STAFF RECOMMENDATION
1026 Chicamauga Avenue
September 17, 2014

Application: Demolition—primary structure; New construction—infill
District: Greenwood Neighborhood Conservation Zoning Overlay
Council District: 06
Map and Parcel Number: 08305007500
Applicant: Jeff Livingston
Project Lead: Melissa Baldock, melissa.baldock@nashville.gov

<p>Description of Project: Application is to demolish the primary structure on the lot and to construct new single-family infill.</p> <p>Recommendation Summary: Staff recommends approval of the demolition and infill with the following conditions:</p> <ol style="list-style-type: none"> 1. The finished floor height shall be consistent with the finished floor heights of the adjacent historic houses, to be verified by MHZC staff in the field; 2. The front of the house be pushed back between four and eight feet (4' – 8'); 3. Staff approve the color of the asphalt shingle roof; 4. A walkway be added from the sidewalk to the porch steps; 5. The window openings on the left elevation, first floor, be altered to meet the historic proportion and rhythm of openings; and 6. The HVAC be located behind the house or on either side, beyond the mid-point of the house.

Figure 1. 1026 Chicamauga Avenue.

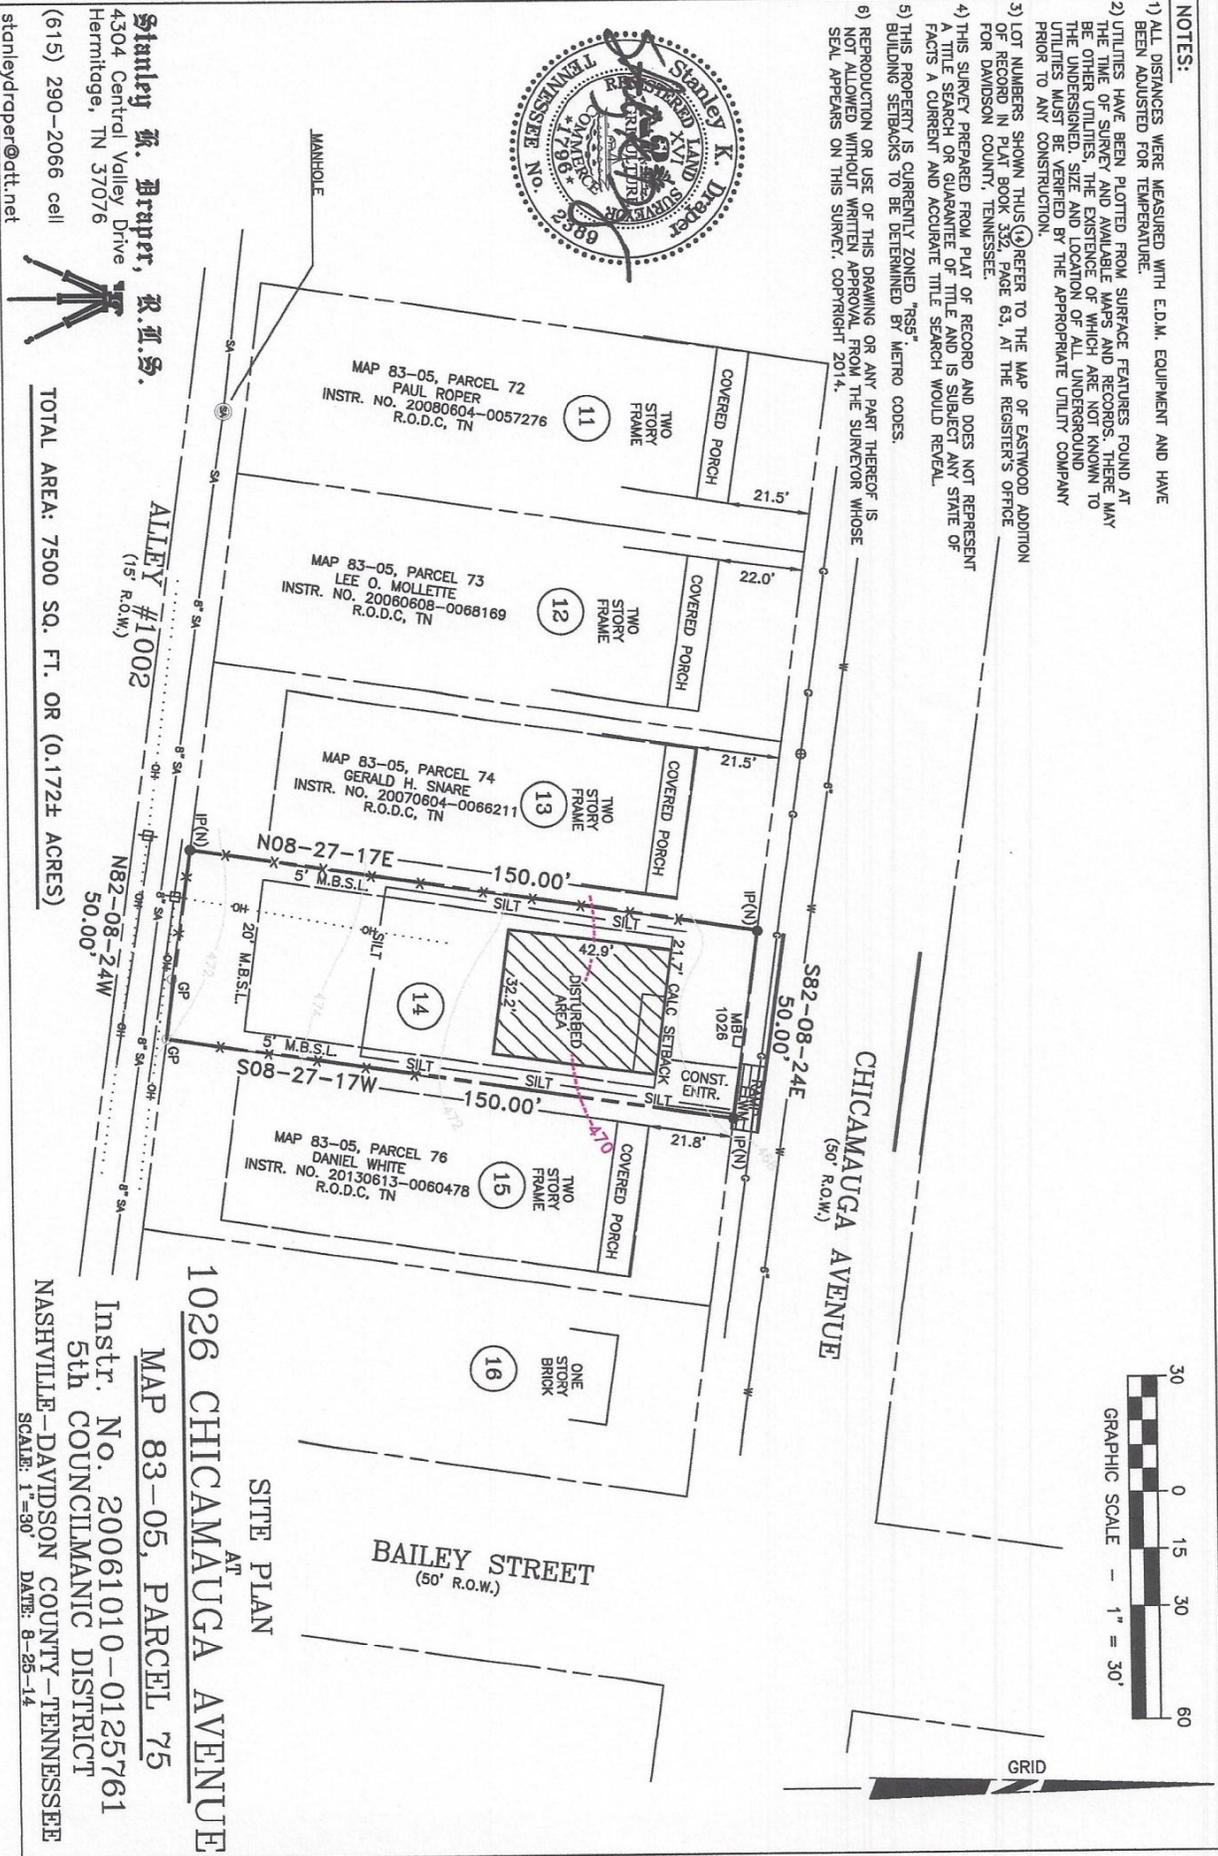
Background: 1026 Chicamauga Avenue is a double-wide mobile home that was installed on the site c. 2001 (Figure 1). The structure does not contribute to the historic character of the Greenwood Neighborhood Conservation Overlay.

Demolition: The existing structure on the lot is a double-wide mobile home that was installed c. 2001. The structure's date of construction, materials, lack of a foundation, lack of architectural details, and orientation away from Chicamauga Avenue do not meet the historic context of the Greenwood neighborhood. Staff therefore finds that the demolition meets Section III.B.2 for appropriate demolition and does not meet section III.B.1 for inappropriate demolition.

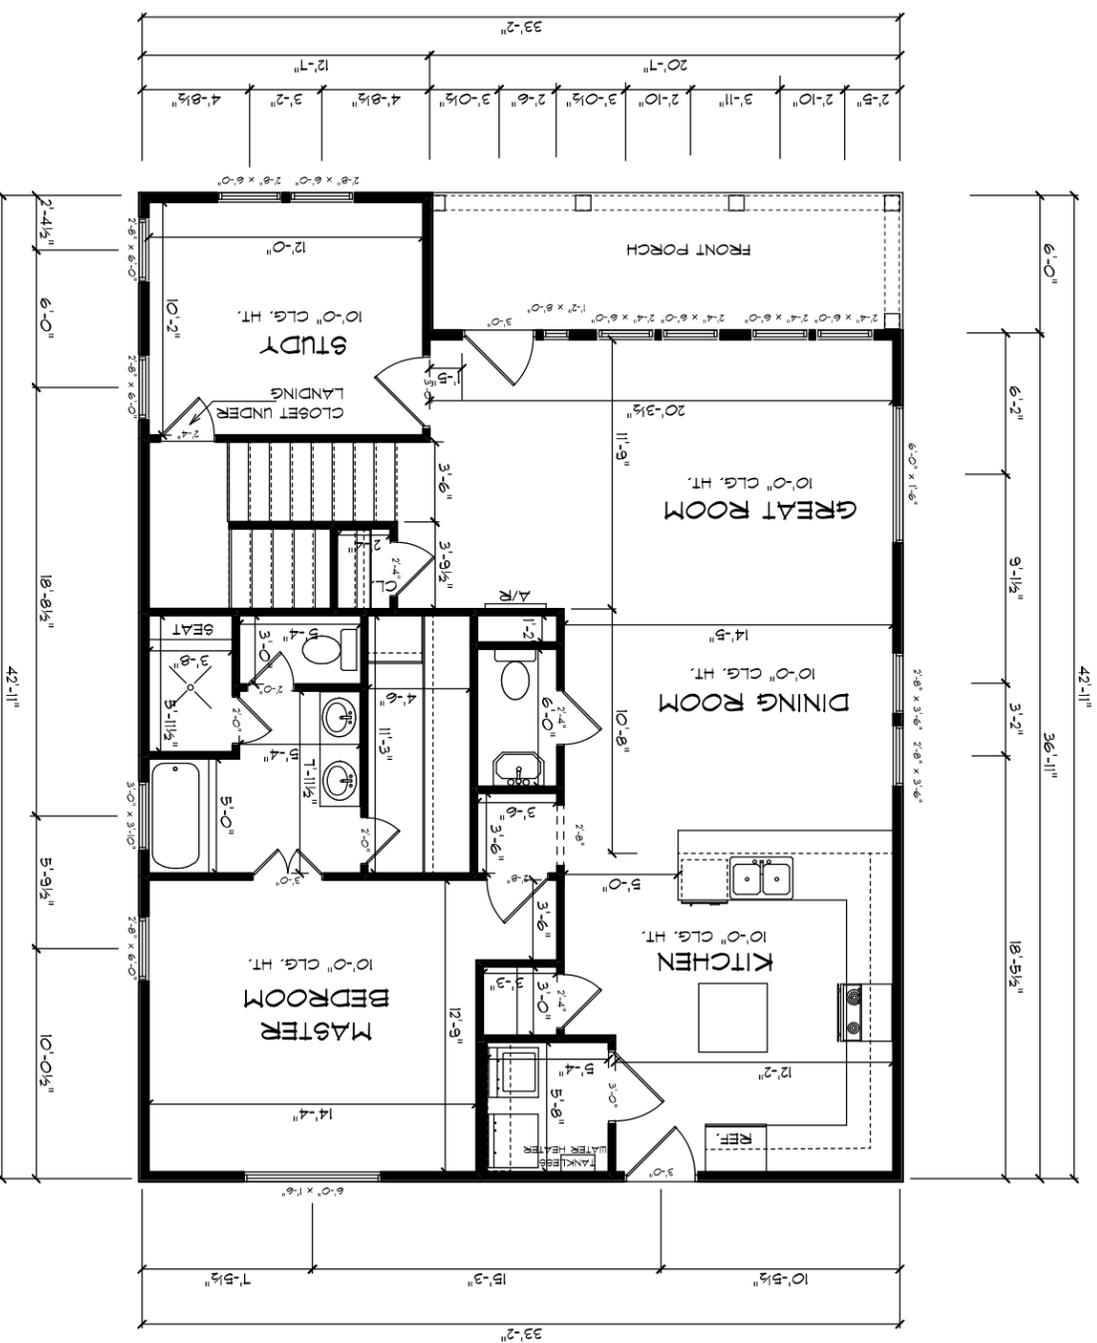
Setback & Rhythm of Spacing: The proposed infill will be centered on the lot and will meet all base zoning requirements for setbacks. Its front setback is situated so that the front wall of the house and its partial width front porch will match the front setbacks of the full-width front porches on either side. Staff asks that the infill be pushed back between four and eight feet (4' – 8') so that the front wall of the house either lines up with the front walls of the houses on either side, or so that the front wall of the house is halfway between the line of the neighboring front porches and the neighboring front walls. With this condition, staff finds that the infill's setback and rhythm of spacing meet Section II.B.1.c. of the *Greenwood Neighborhood Conservation Zoning Overlay: Handbook and Design Guidelines*.

Orientation: The house is oriented to face Chicamauga Avenue. It has a partial-width front porch that is six feet (6') deep. Staff asks that a walkway be added from the sidewalk leading to the front entryway. No driveway was indicated on the site plans. With the addition of the walkway, staff finds that the infill's orientation meets section II.B.1.f. of the *Greenwood Neighborhood Conservation Zoning Overlay: Handbook and Design Guidelines*.

Appurtenances & Utilities: No changes to the site's appurtenances were indicated on the drawings. The location of the HVAC and other utilities was not noted. Staff asks that the HVAC be located on the rear façade, or on a side façade beyond the midpoint of the house.

1. The finished floor height shall be consistent with the finished floor heights of the adjacent historic houses, to be verified by MHZC staff in the field;
2. The front of the house be pushed back between four and eight feet (4' – 8');
3. Staff approve the color of the asphalt shingle roof;
4. A walkway be added from the sidewalk to the porch steps;
5. The window openings on the left elevation, first floor, be altered to meet the historic proportion and rhythm of openings; and
6. The HVAC be located behind the house or on either side, beyond the mid-point of the house.

FRONT ELEVATION

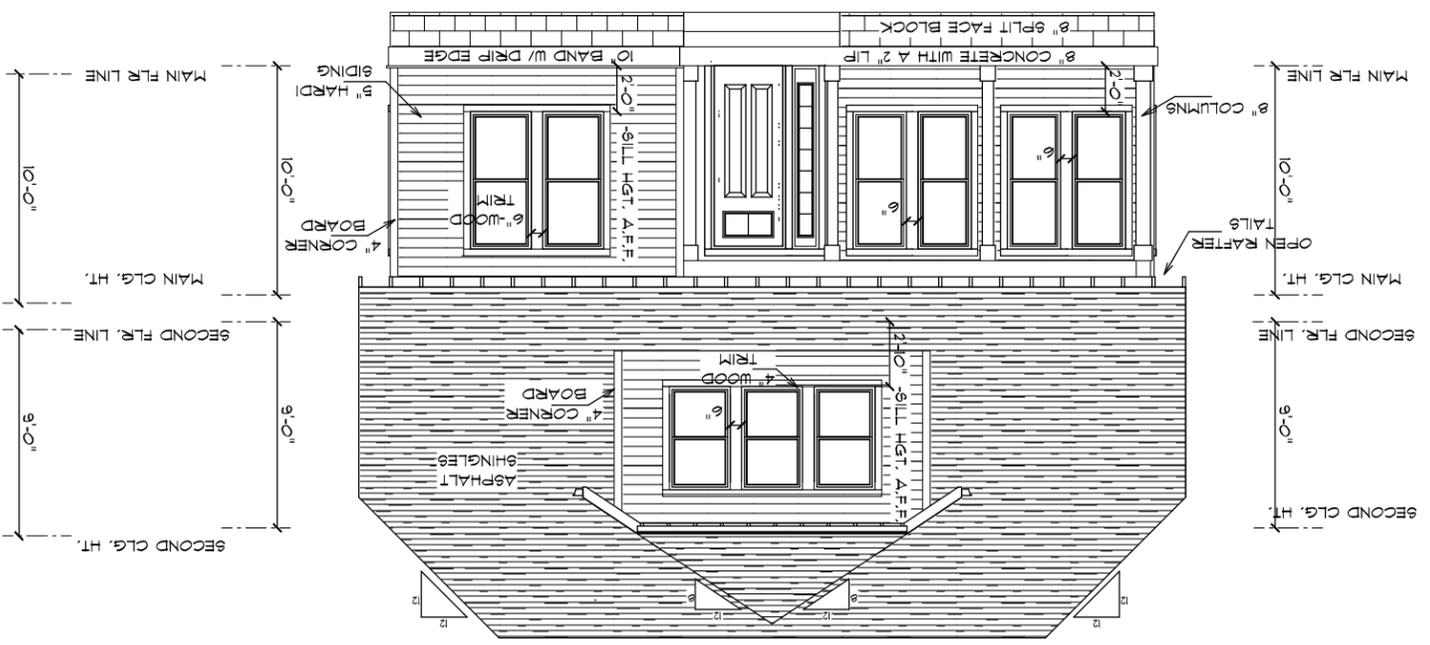
Roof form: The primary roof form will be a side-clipped gable with a slope of 12/12. A clipped gable front dormer will have a slope of 8/12. The dormer will be situated off the ridge of the house and will be setback three feet (3') from the wall below. A rear shed dormer will have a slope of 3/12. Staff finds that the infill's roof forms meet Section

Proportion and Rhythm of Openings: The windows on the front façade meet the proportion of historic window openings, as they are at least twice as tall as they are wide, and the windows in the dormer are shorter than those on the first floor. On the side façade, staff requests that several of the window openings be altered to ensure they meet the design guidelines. On the left elevation, staff asks that the horizontal window opening in the "Great Room" be a more traditional, vertically oriented window opening. Also on the left elevation, staff asks that a window opening of at least four square feet (4 sq. ft.) be added towards the back of the house where there is an expanse of approximately seventeen feet (17') without a window or door opening. With these changes, staff finds the infill's proportion and rhythm of openings meet Section II.B.1.g. of the *Greenwood Neighborhood Conservation Zoning Overlay: Handbook and Design Guidelines*.
